**Version 0 Reliability Standards
Alternatives for Tagging of Dynamic Schedules
September 10, 2004**

PLEASE COMMENT USING THE VERSION 0 DRAFT 2 COMMENT FORM — QUESTION 3.

Figure 1 – Interpretation of Existing Policy

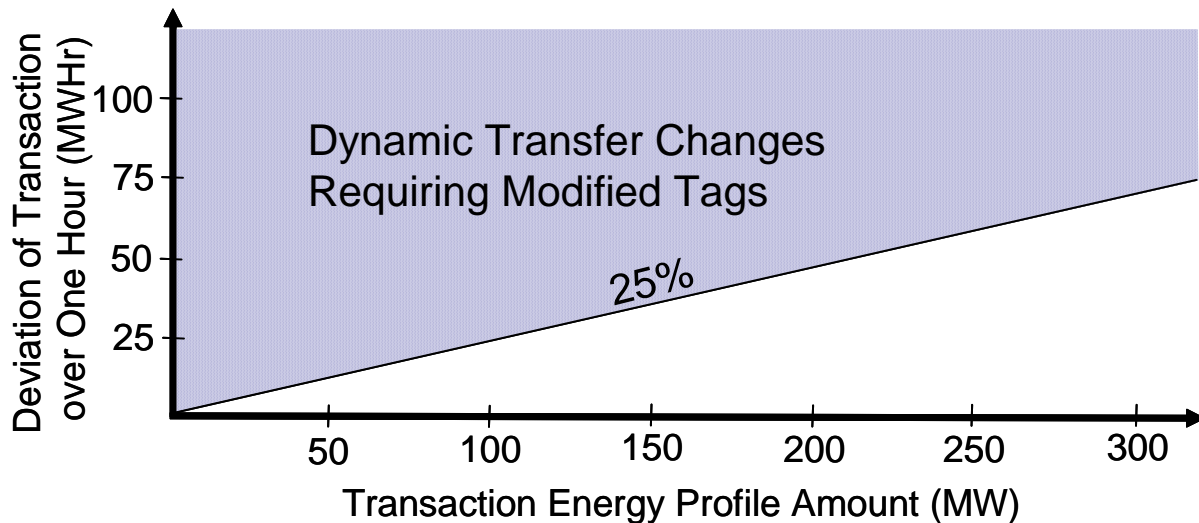
Alternative A is to preserve the intent of current policy and simply sharpen the language to remove ambiguities (Figure 1):

- R5 [3A 2.1 and P3T4] The Purchasing-Selling Entity responsible for tagging a Dynamic Interchange Schedule shall ensure the tag is updated for the next available scheduling hour and future hours if at any time the actual hourly integrated energy deviates from the hourly average energy profile indicated on the tag by more than $\pm 25\%$.

Figure 2 – Proposed Alternative for Version 0

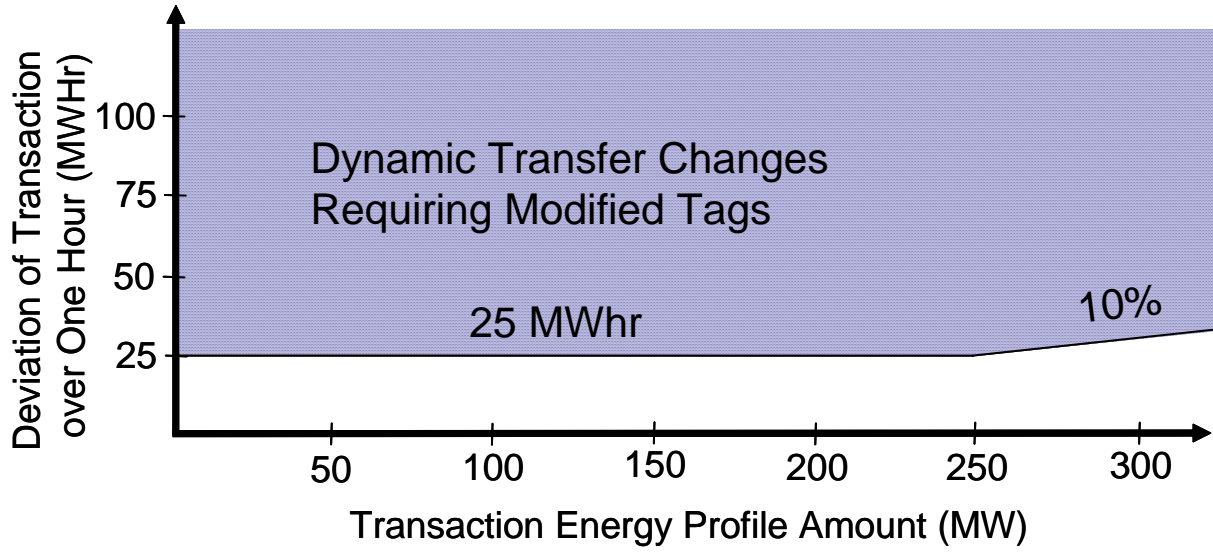
Alternative B is to correct the deficiency in the standard in Version 0 with a suitable replacement (Figure 2):

- R5 The Purchasing-Selling Entity responsible for tagging a Dynamic Interchange Schedule shall ensure the tag is updated for the next available scheduling hour and future hours when any one of the following occur:

- R5.1 The average energy profile in an hour is greater than **250 MW** and in that hour the actual hourly integrated energy deviates from the hourly average energy profile indicated on the tag by more than $\pm 10\%$.

- R5.2 The average energy profile in an hour is less than or equal to **250 MW** and in that hour the actual hourly integrated energy deviates from the hourly average energy profile indicated on the tag by more than ± 25 megawatt-hours.

- R5.3 A Reliability Coordinator, Reliability Authority, or Transmission Operator determines the deviation, regardless of magnitude, to be a reliability concern and notifies the Purchasing-Selling Entity of that determination and the reasons.
